737

Service Bulletin

Number: 737-28A1206
Original Issue: January 11, 2006
Revision 2: May 21, 2009
ATA System: 2822 3152

SUBJECT: FUEL - Distribution - Center Fuel Tank Boost Pump Auto Shutoff and Master Caution Logic Change

FIGURE 37: W0044 WIRE BUNDLE ROUTING

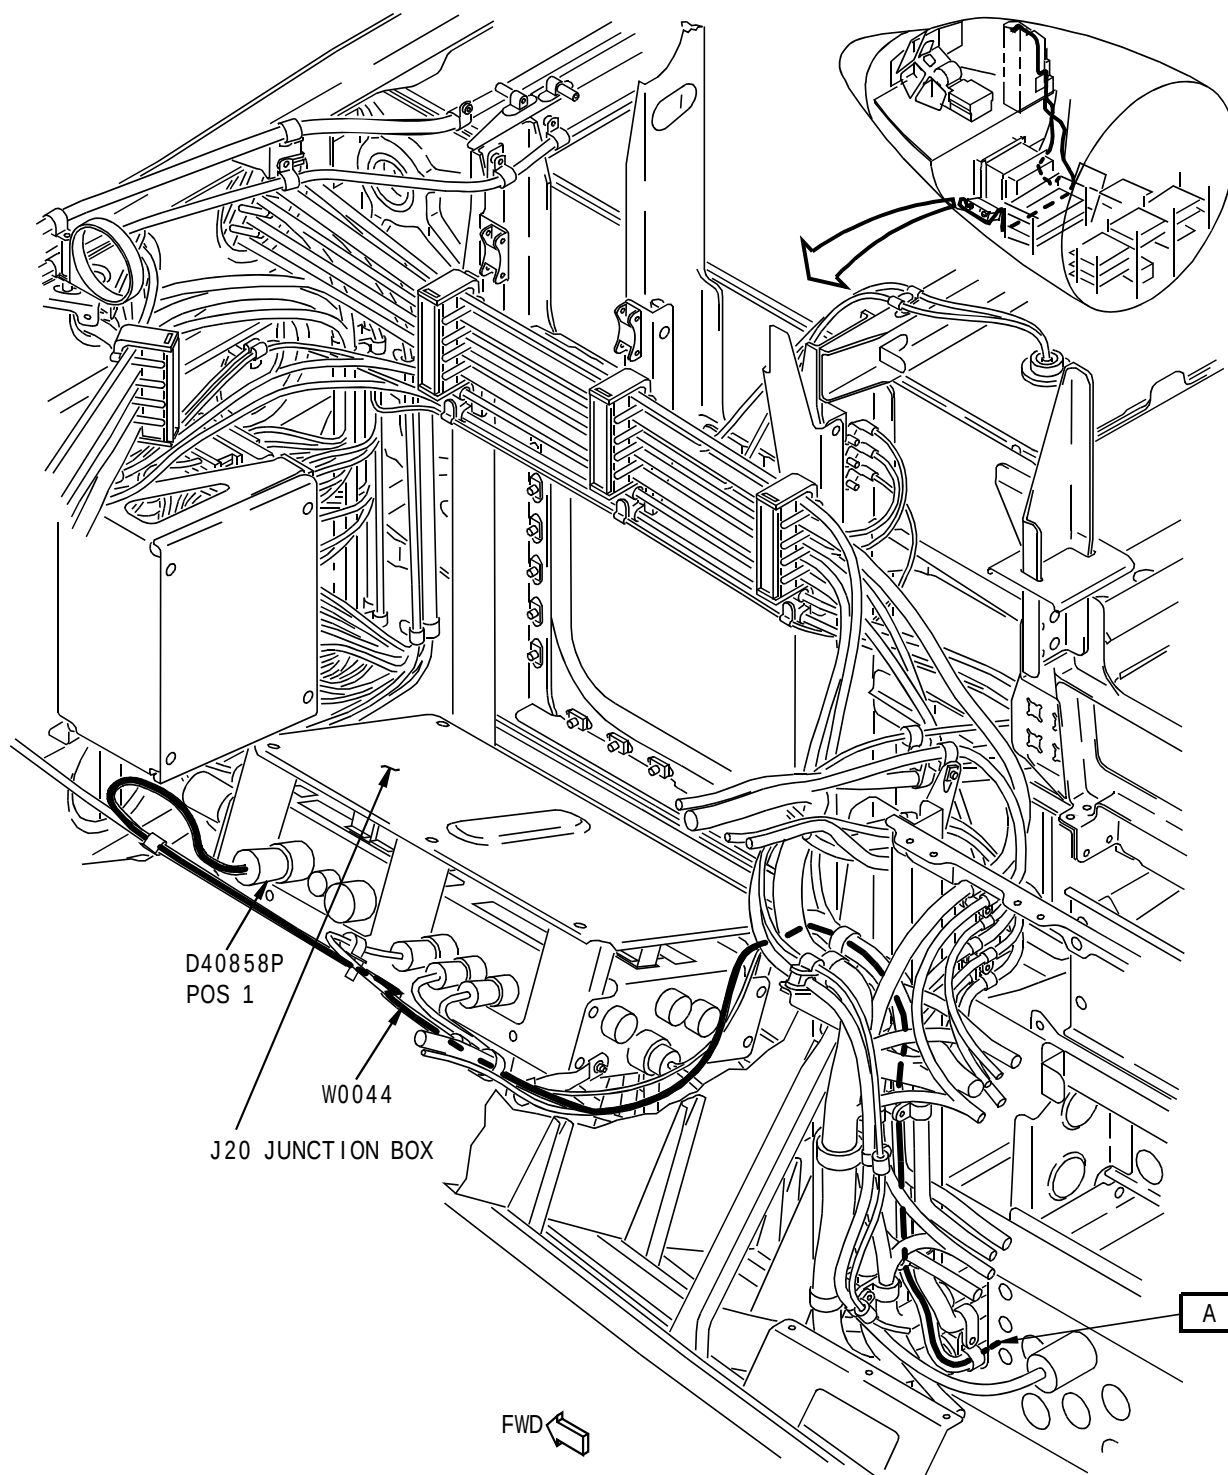
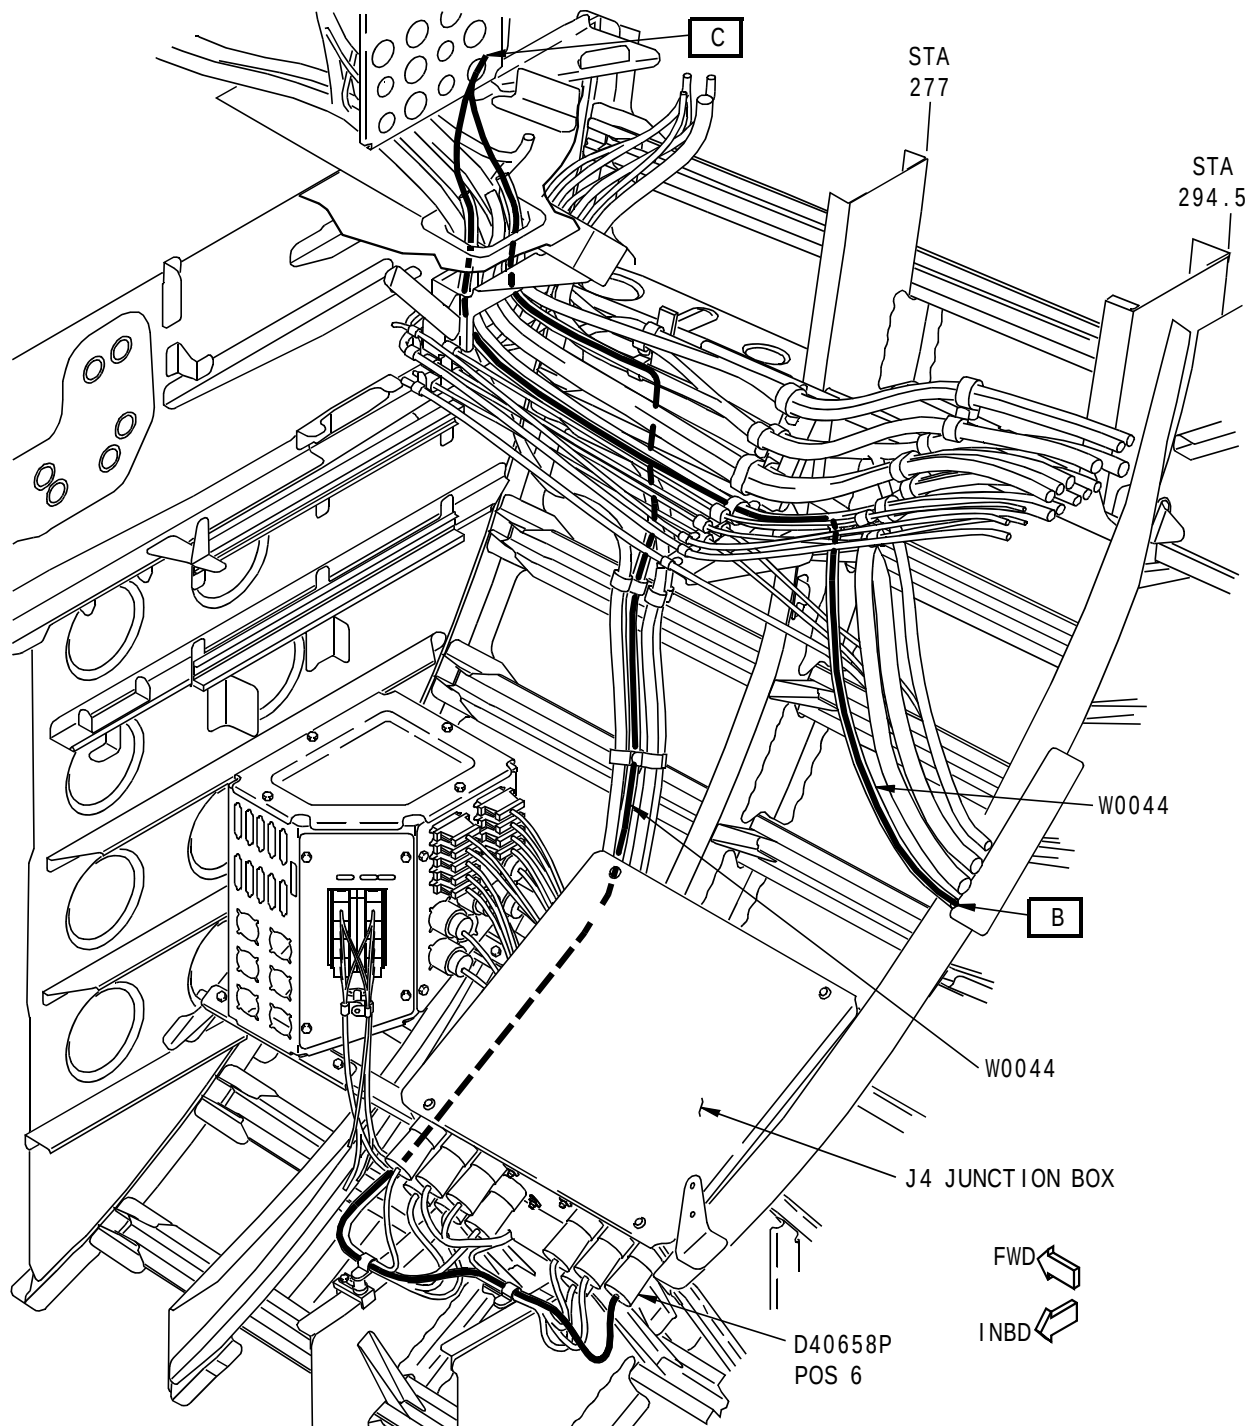
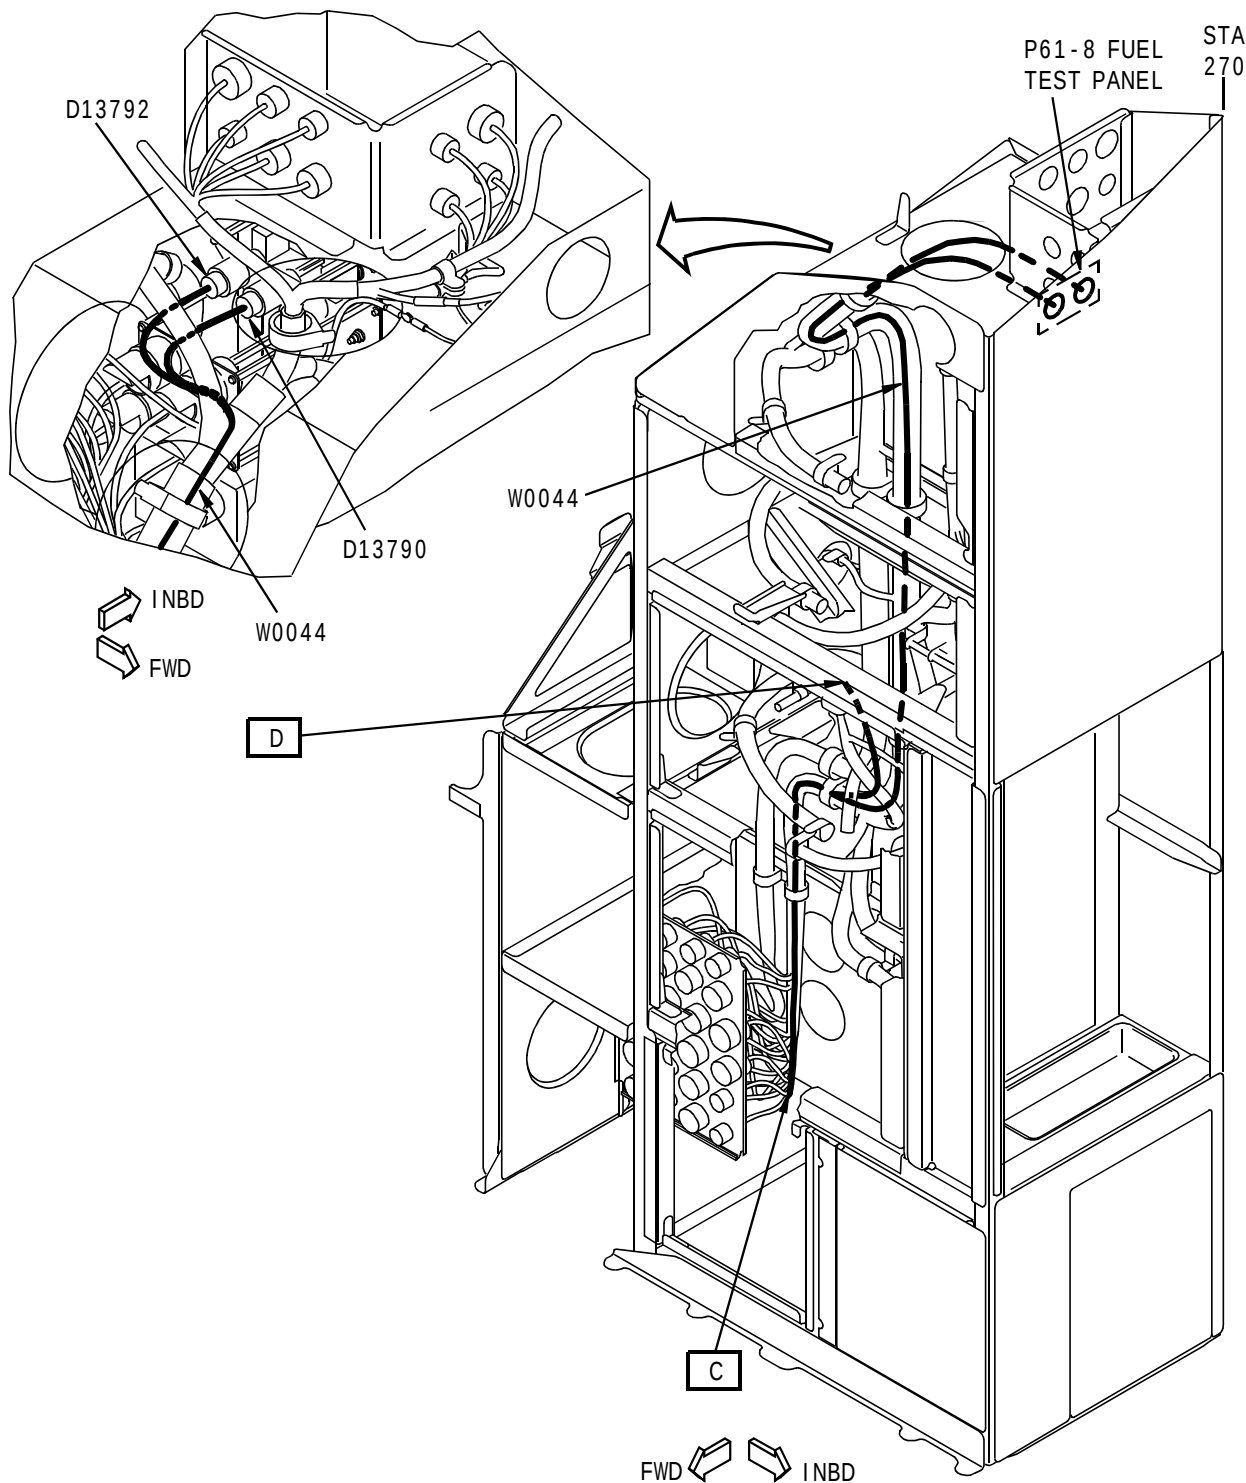
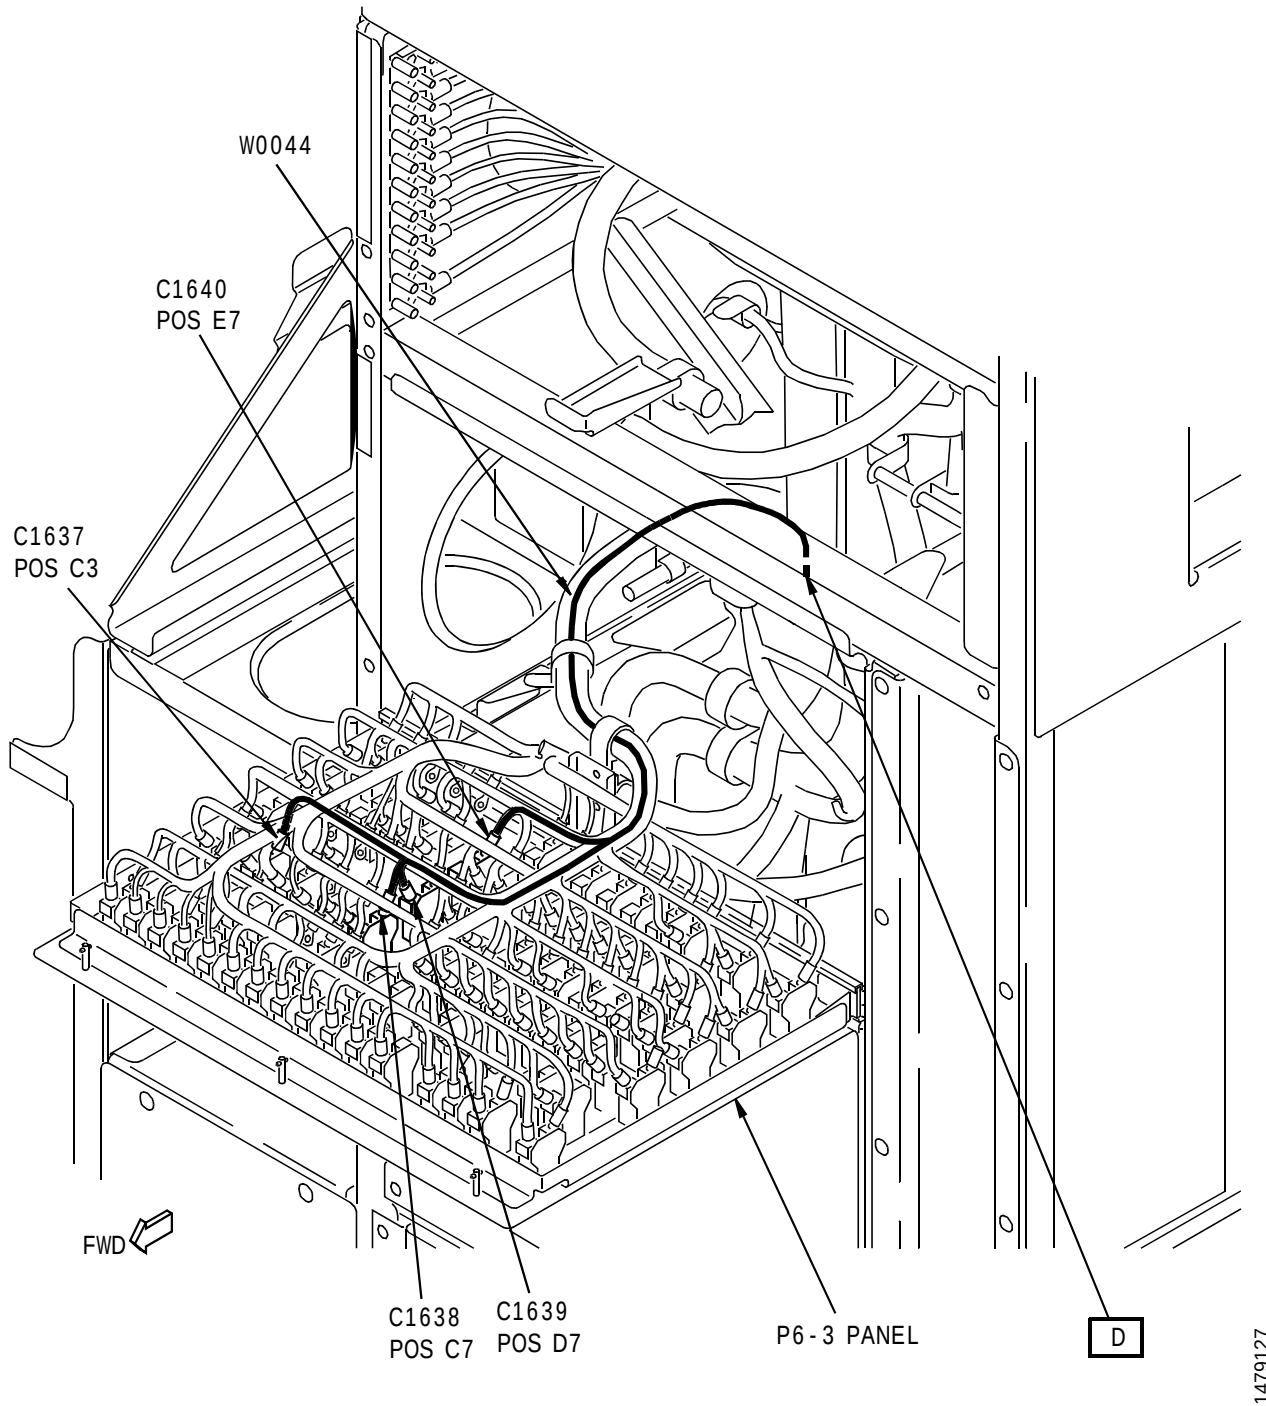
Changes are made to Figure 37 to show the route of wire bundle W0044 to the P6-3 circuit breaker panel.

FIGURE 38: WIRE BUNDLE W0044 WIRING CHANGE

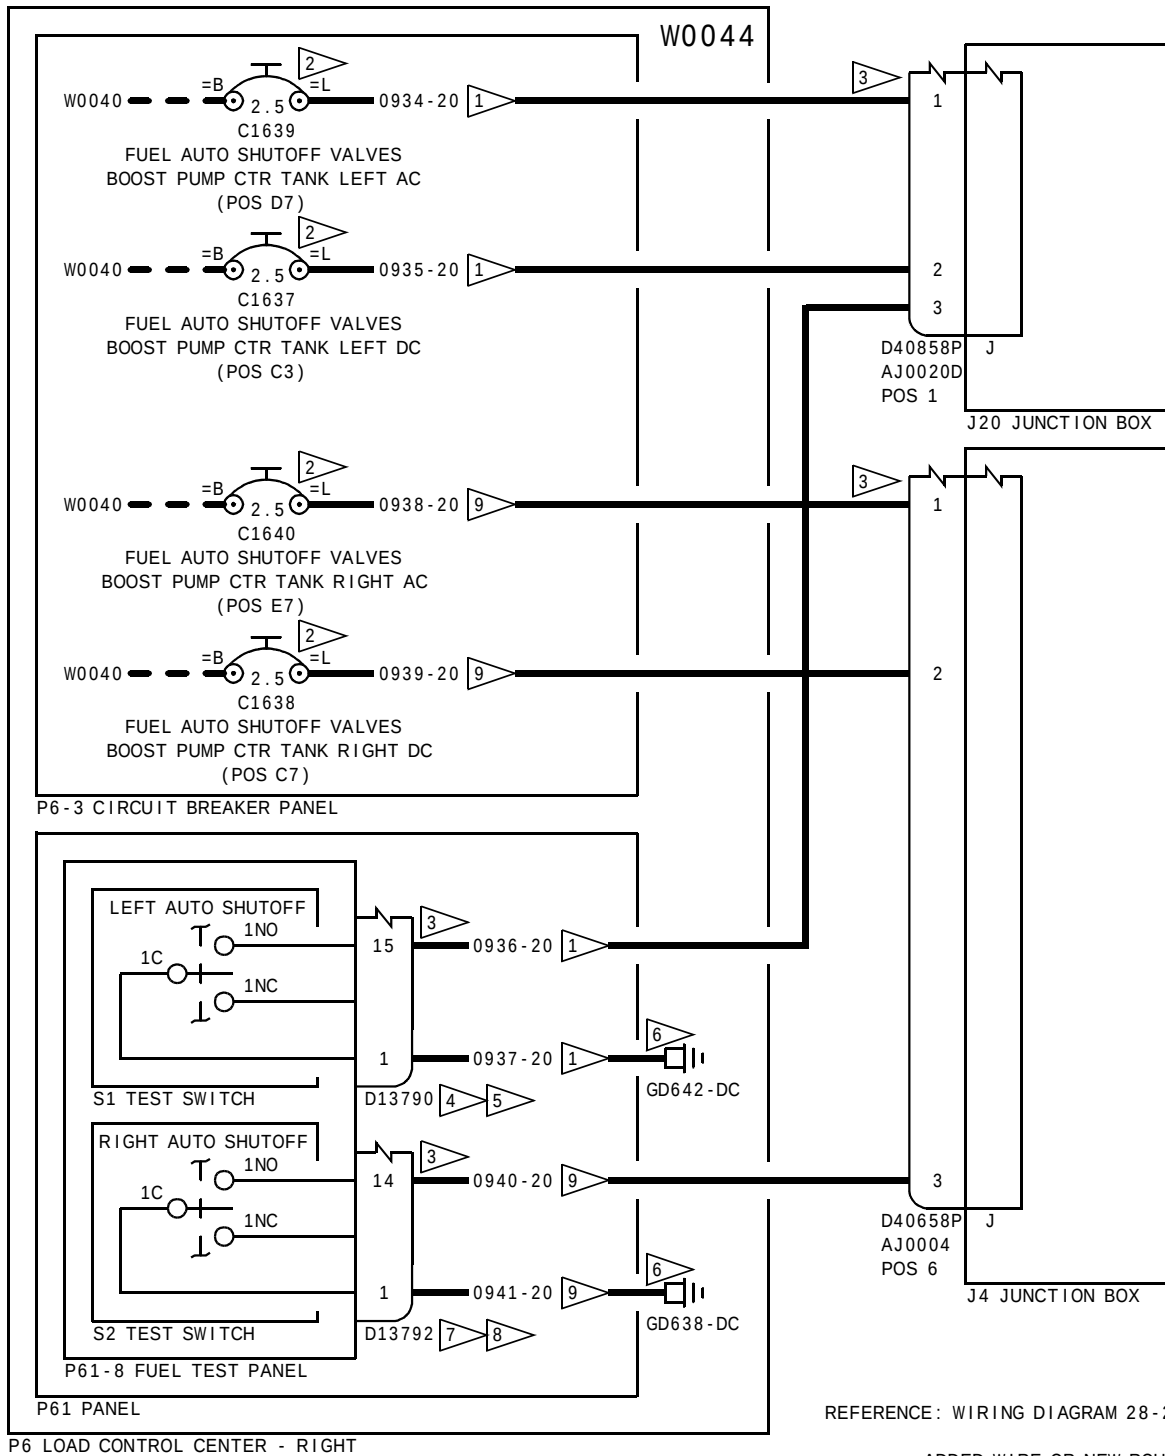
Changes are made to Figure 38 to change Wire identification from BMS 13-60, Type 1, Class 1, AWG 20 to BMS 13-48, Type 10, Class 1, AWG 20. The name of the Terminal Module is changed to read Contact, Pin. Changes are also made to change I.D. Tape part number 280A3113-10201 to 280A3113-11201, I.D. Tape part number 280A3113-10202 to 280A3113-11202, and Filler Rods part number 280A3113-10203 to 280A3113-11203.
